**Re: BG 22-104- Christian Co. - New Consolidated High School
Design Development Review - Response**

The following is our response to your Schematic Design Review Dated 3/7/22, item by item:

FIRST FLOOR PLAN - Item 4C
1" = 40'-0"

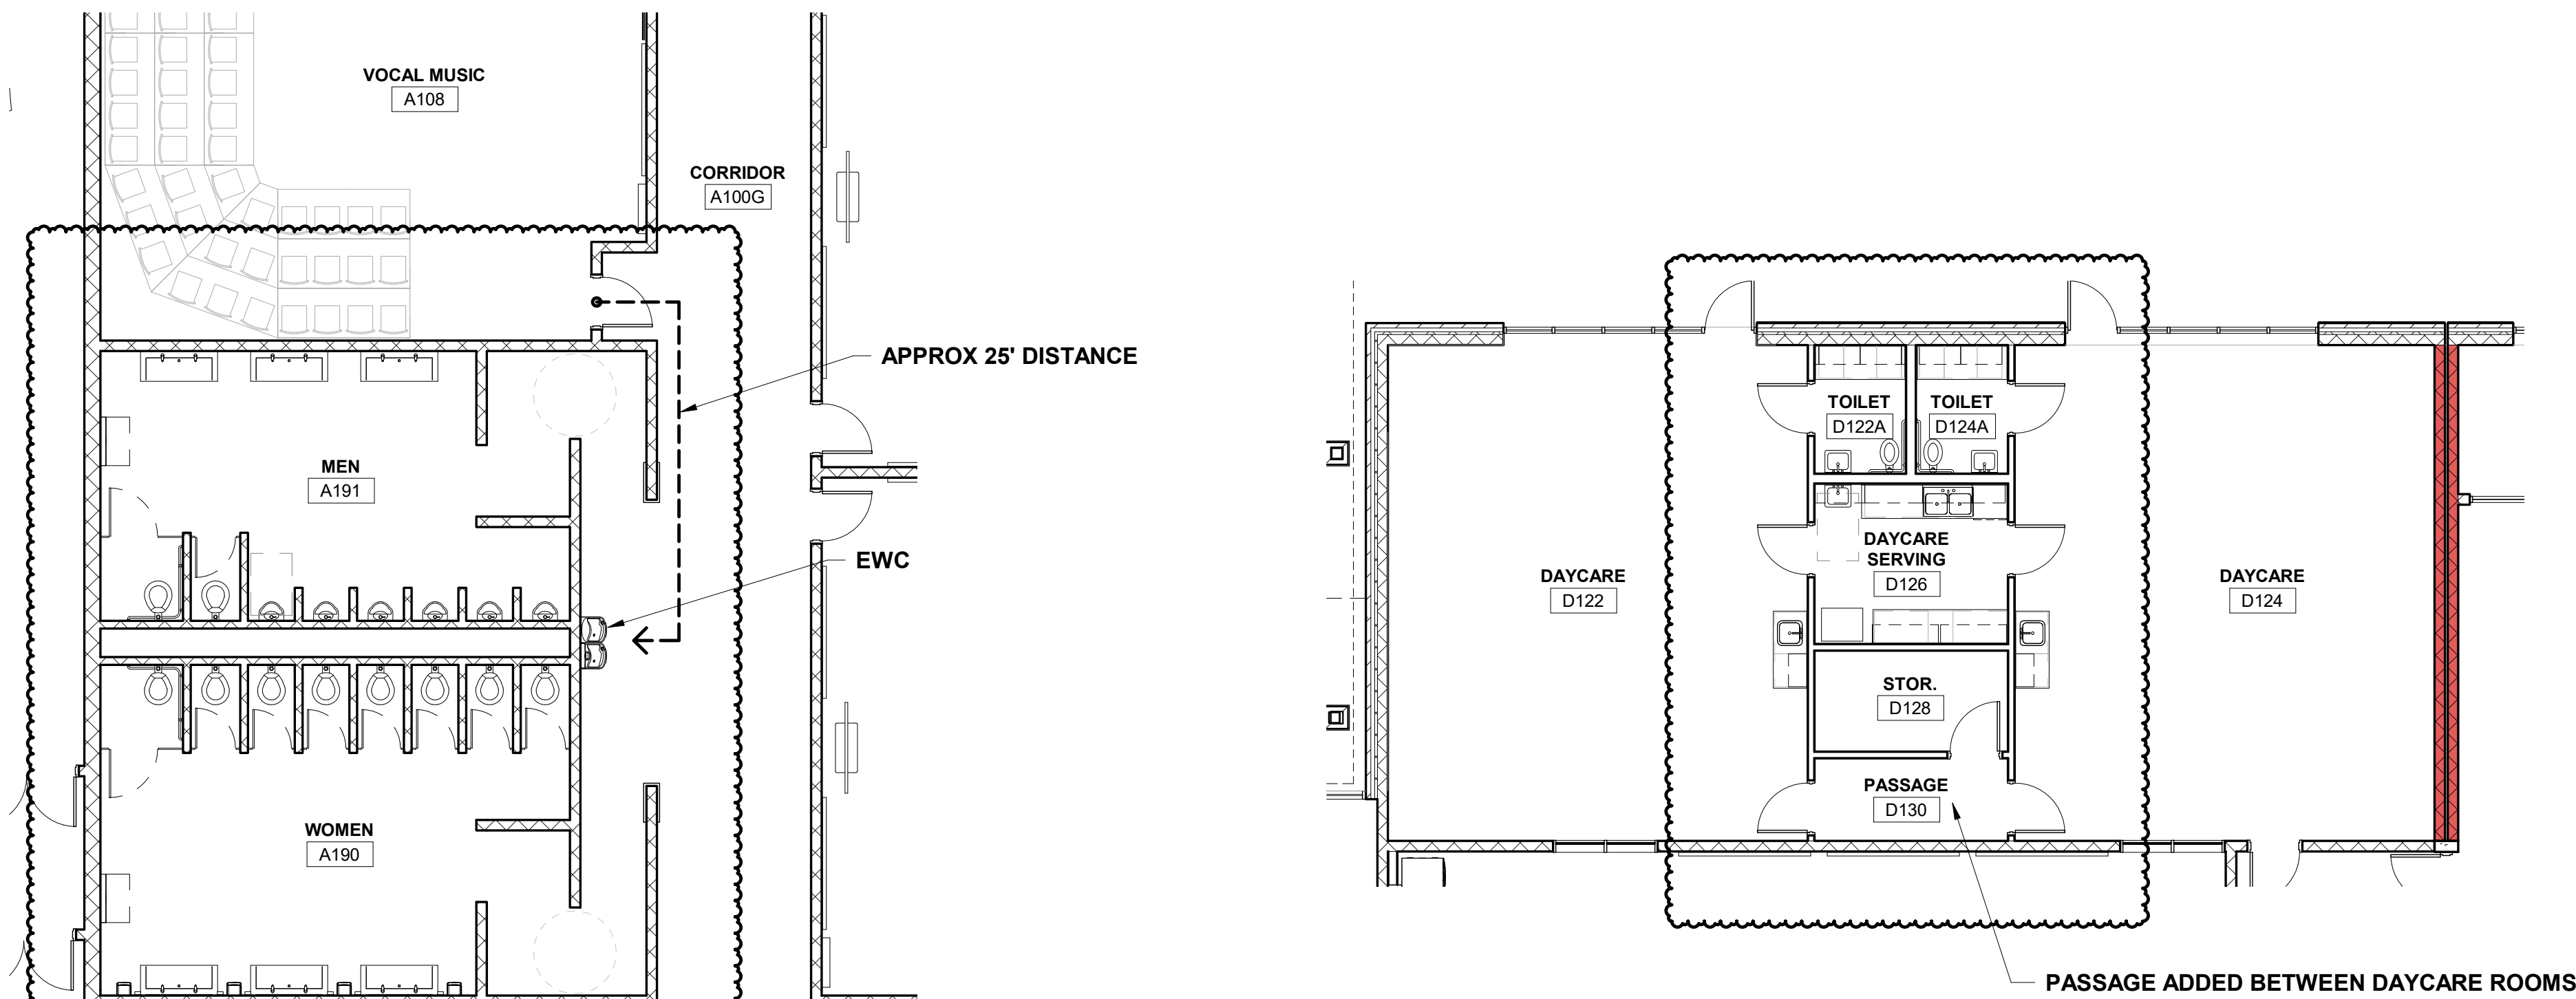
RESPONSE ITEM 4C: Part 2b.1.3 Standard Classrooms – Demonstrate space is available for 2,500-12”x12”x36” lockers for all students. District may request a waiver to install however, space in the building should demonstrate the feasibility to place lockers in the future should the district decide to do so.

RESPONSE ITEM 5: The BG-2 notes no lockers. Lockers are provided in accordance with Construction Criteria as referenced in 702KAR 4:170. RESPONSE ITEM 4c is adequate to address this concern.

RESPONSE: At this time, the school administration stated that their students do not use lockers and would like to omit them from the project. After consideration of your previous questions about the availability and usefulness to have some lockers for students with disabilities, injuries or other conditions, we are installing a minimum of 50 lockers in each academy for a total of 250 lockers during construction to cover 10% of the student population. In the event that the school district would ever want to install additional lockers in the school for the entire student population, this can be achieved due to the corridors being 12” wider than is required by KDE minimum corridor standards. See attached for plans that indicates there is potentials space for 3,120 lockers in the school (Sheet DDR1). A waiver will be submitted for the remainder of the lockers.

RESPONSE: At this time, the school administration stated that their students do not use lockers and would like to omit them from the project. After consideration of your previous questions about the availability and usefulness to have some lockers for students with disabilities, injuries or other conditions, we are installing a minimum of 50 lockers in each academy during construction to cover 10% of the student population. In the event that the school district would ever want to install additional lockers in the school for the entire student population, this can be achieved. See attached for plan DDR - #5 that indicates there is potential space for 3,120 lockers in the school.

Item 9 - Vocal Room to EWC
1/8" = 1'-0"

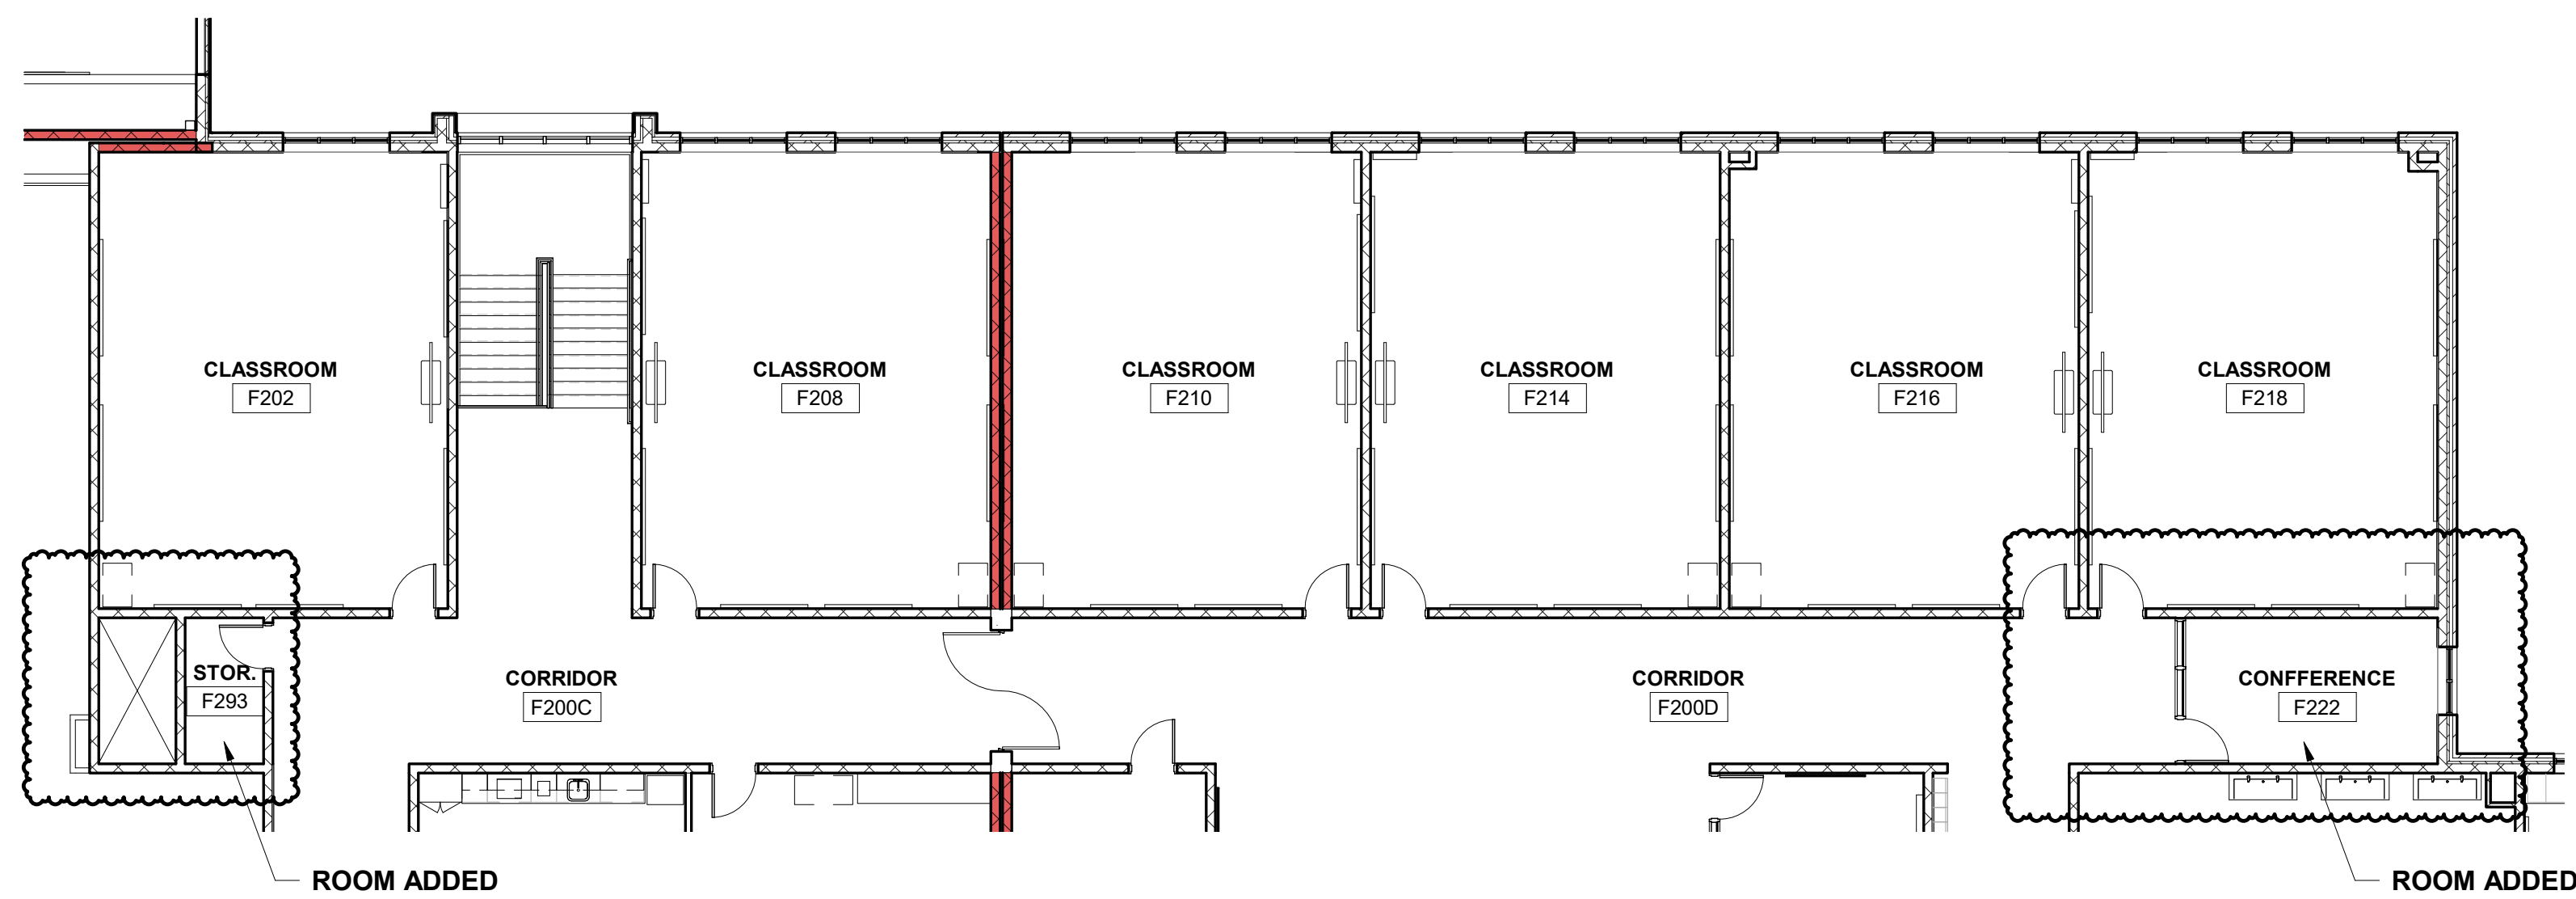
RESPONSE ITEM 9: Vocal Music Classrooms should be readily accessible to an electric water cooler or water bottle filling station.

RESPONSE: An electric water cooler with water bottle filling station is directly adjacent to the vocal room and is located approximately 25' away from the main vocal room door. However, if a EWC is required to be inside of the vocal room, let us know and we will provide one. See attached floor plan for clarification (Sheet DD3 – Item 9).

Item 4R - F100C & F100D
3/32" = 1'-0"

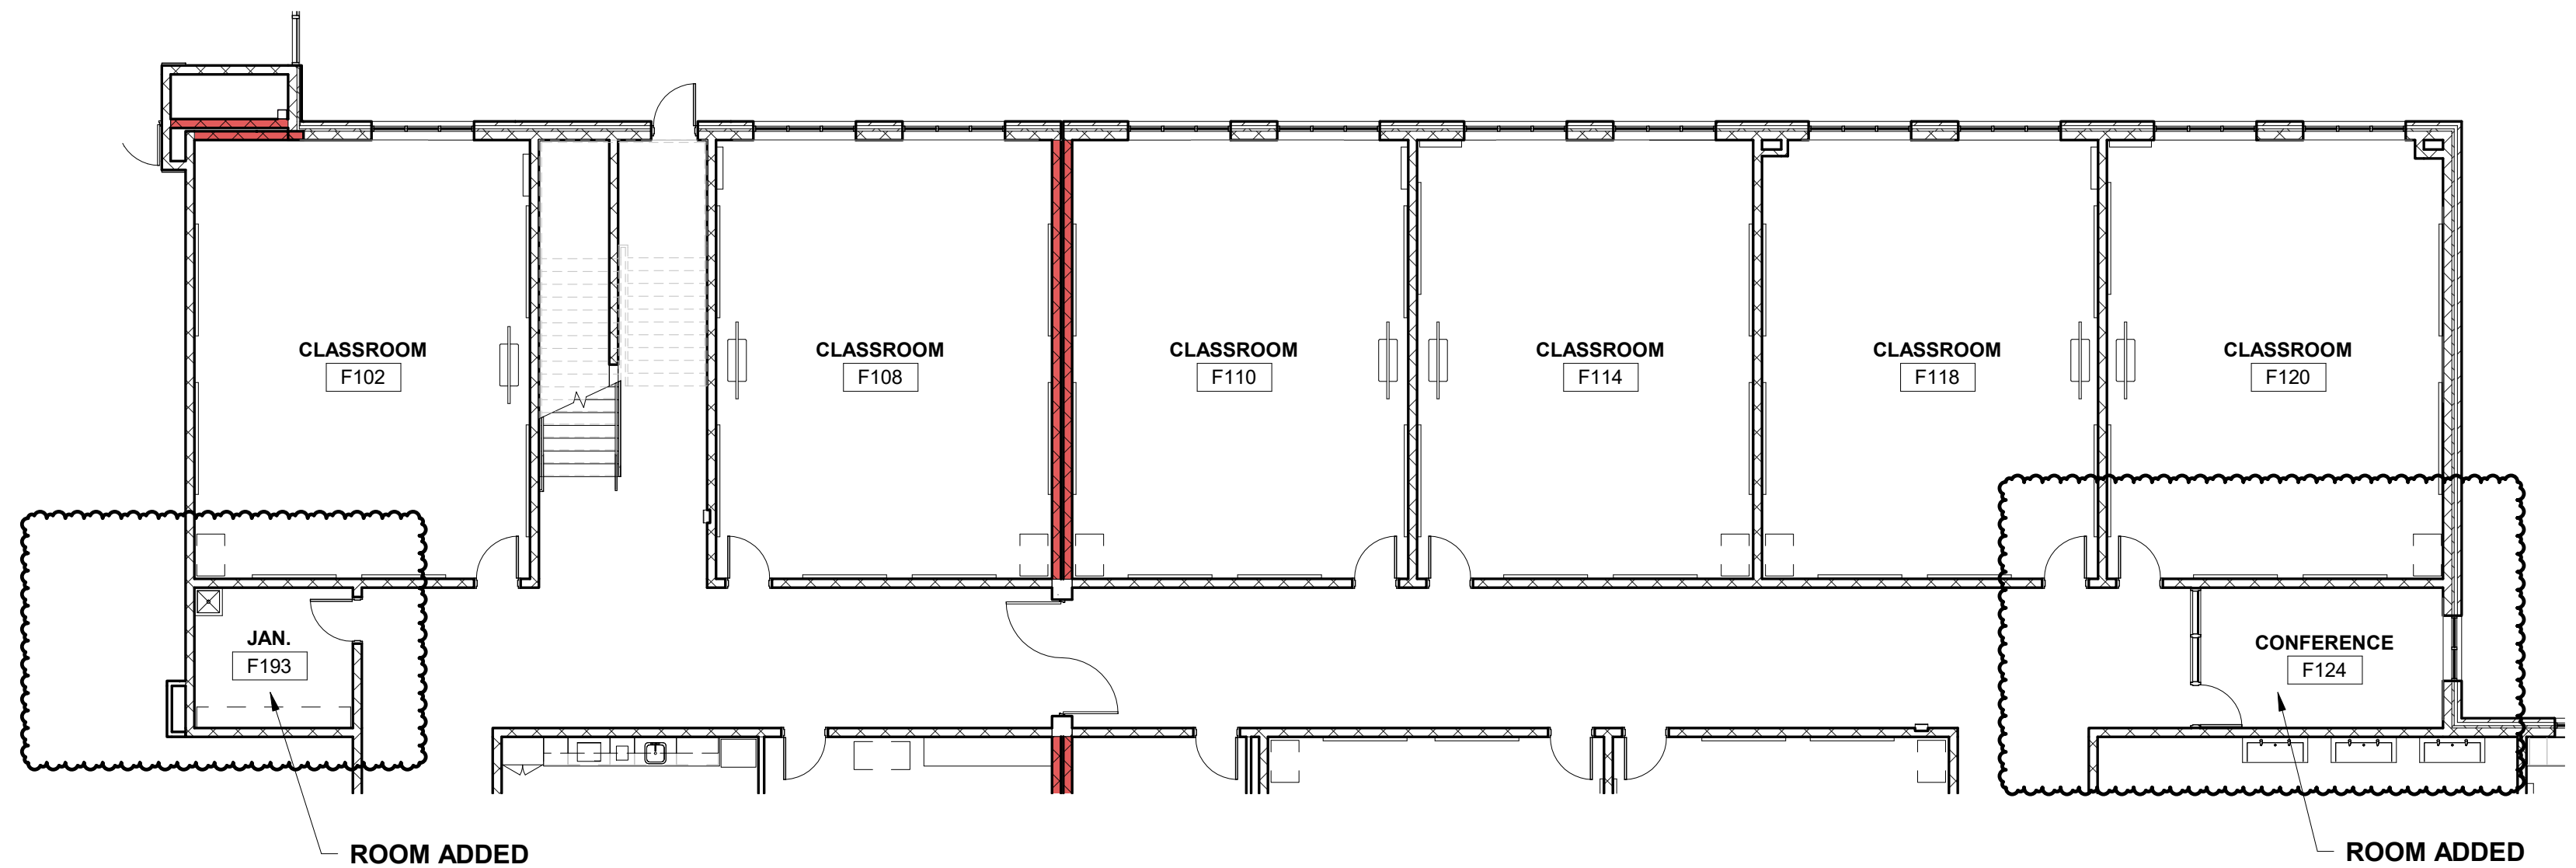
RESPONSE ITEM 4R: Part 2c.1.1.3 – “Corridors shall terminate at an approved egress or at a stairway which leads directly to an approved egress.” Corridors A100F, E100C, E100D, F100C, F100D, F200C and F200 D do not comply with this requirement.

RESPONSE: Door A100F has been moved to reduce the dead end at corridor A100F to an ‘alcove’. E100C & E100D have been previously revised to eliminate the dead-end conditions. F100C & F200C will include an additional resource room to eliminate the dead-end corridor condition, and the end of F100D has been revised to include a small janitors closet to eliminate the dead end condition. See attached floor plans for revisions to each location (Sheet DDR3 – Items 4R).

Item 4D
1/8" = 1'-0"

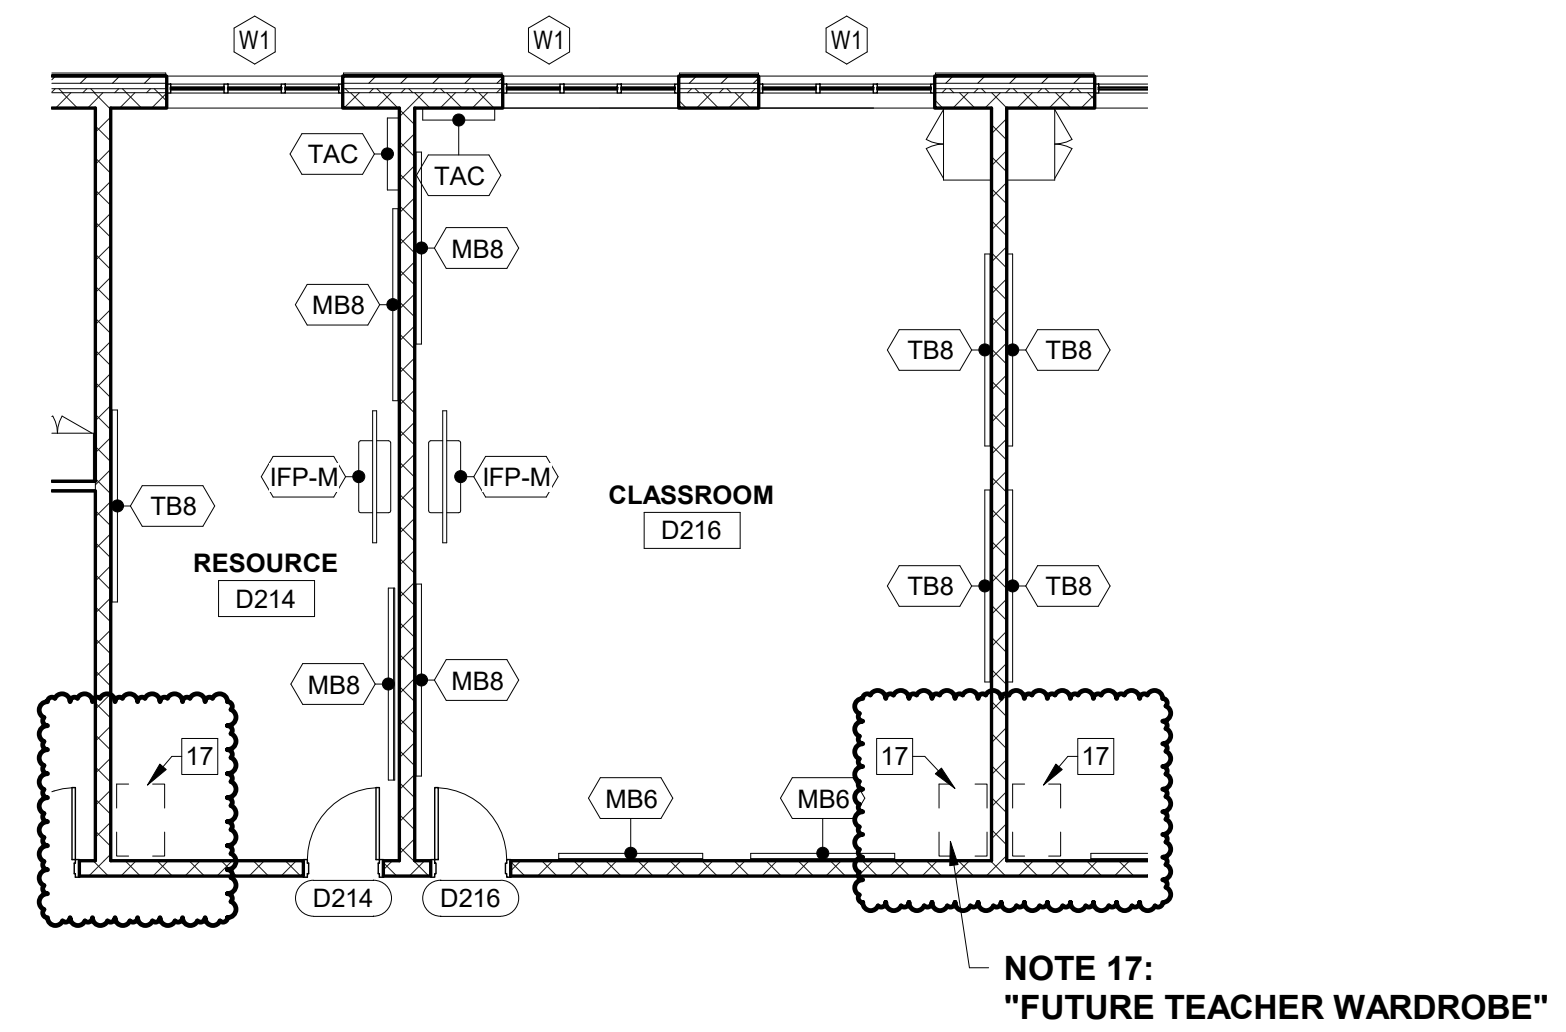
RESPONSE ITEM 4D: Part 2b.1.3 (c) Standard Classrooms – Provide “storage space for teaching materials and records.”

RESPONSE: Due to the request by the administration to not have teachers assigned to a classroom, they requested to omit any storage from the classrooms. However, your concerns about teachers who have trouble with mobility or the need to specialized equipment storage in each resource room for items like headphones for speech therapy are understood. To this end, we are planning for a 2’x3’ space in each classroom where a future teacher’s wardrobe or tall storage cabinet can go. This area will be free of all outlets, devices and marker/tack boards to allow for easy installation of storage in the future as part of the owner’s furniture package, if desired. See attached for floor plans indicating the how this will be documented in our construction documents (Sheet DDR3 – Item 4D).
